# ALERT SERVICE BULLETIN

**Service Bulletin No.:** DAC1-61-00A Rev 1

**Title:** Spinner Rear Bulkhead Replacement

**Figure 1**  
**Obsolete Rear Spinner Bulkheads**  
**Looking Forward**

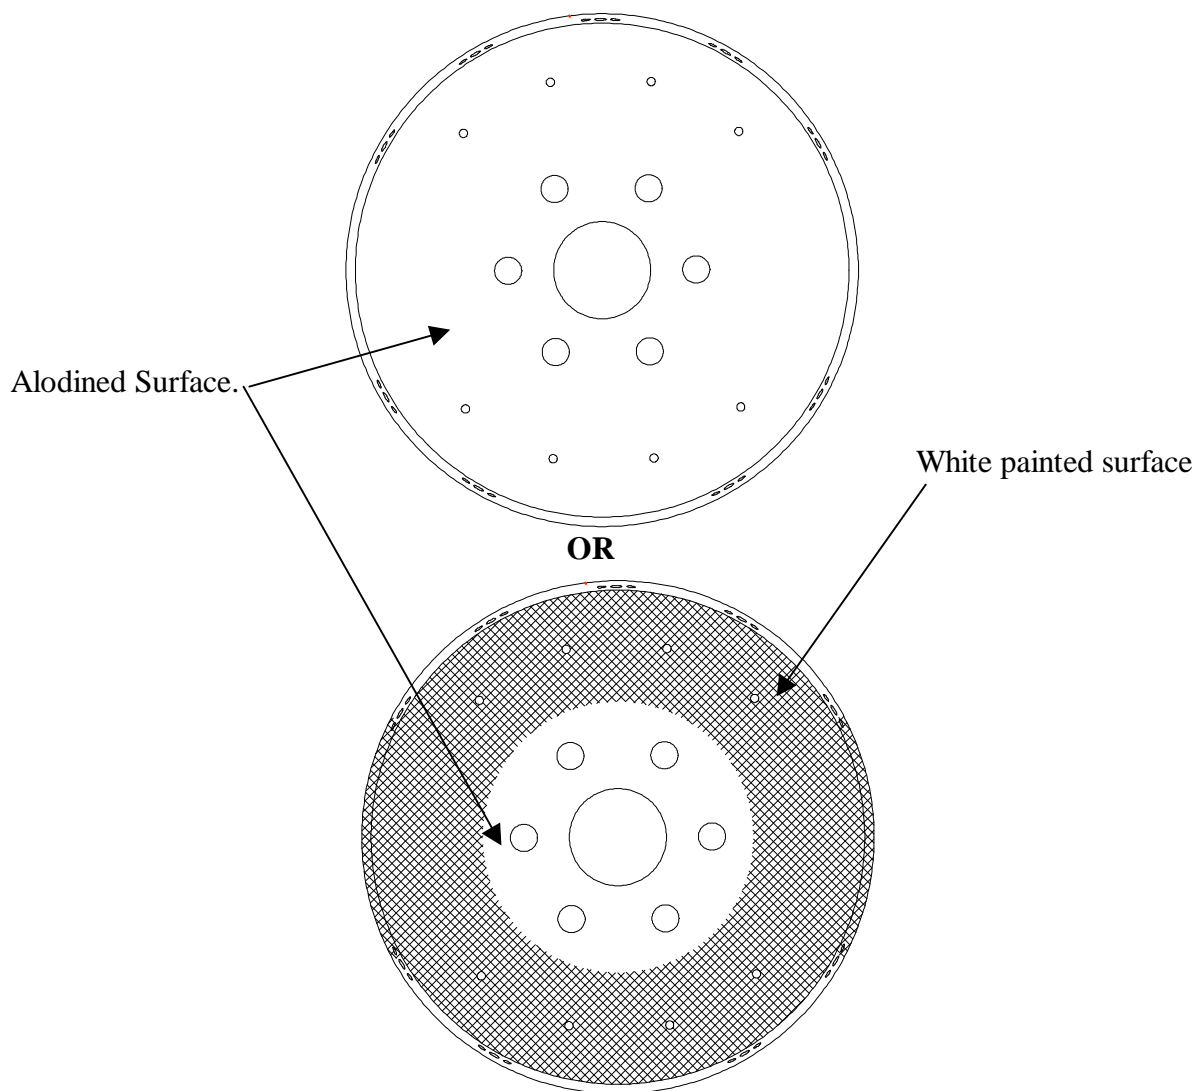
**10.2.** Examine aft face of rear spinner bulkhead. If the aft face of the bulkhead does not have white paint on it where the propeller extension attaches to the propeller or is completely bare of paint, **PART 2 must be accomplished**. If positive identification can not be determined the propeller must be removed and rear bulkhead identified. **Refer to figure 1.**

**Figure 2**  
**Side View**

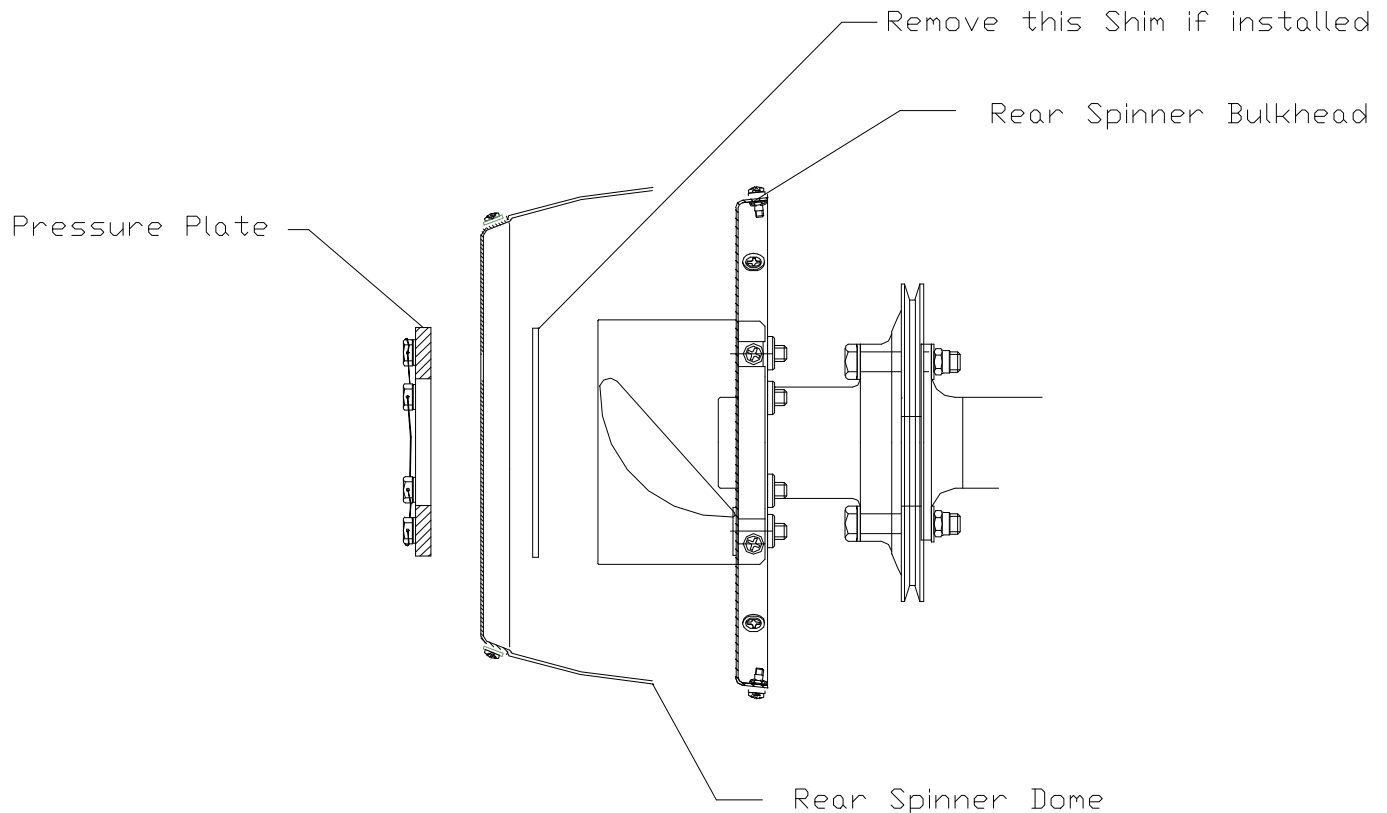
**10.4.** Remove the forward spinner dome. Look to see if there is an anodized aluminum shim located between the rear spinner dome and the propeller, this shim if present has a smaller center hole than the hub bore in the propeller and will be readily visible. If the shim is present it must be removed. Follow the procedure in Part 2 with the exception of the rear spinner bulkhead replacement. **Refer to figure 2.**
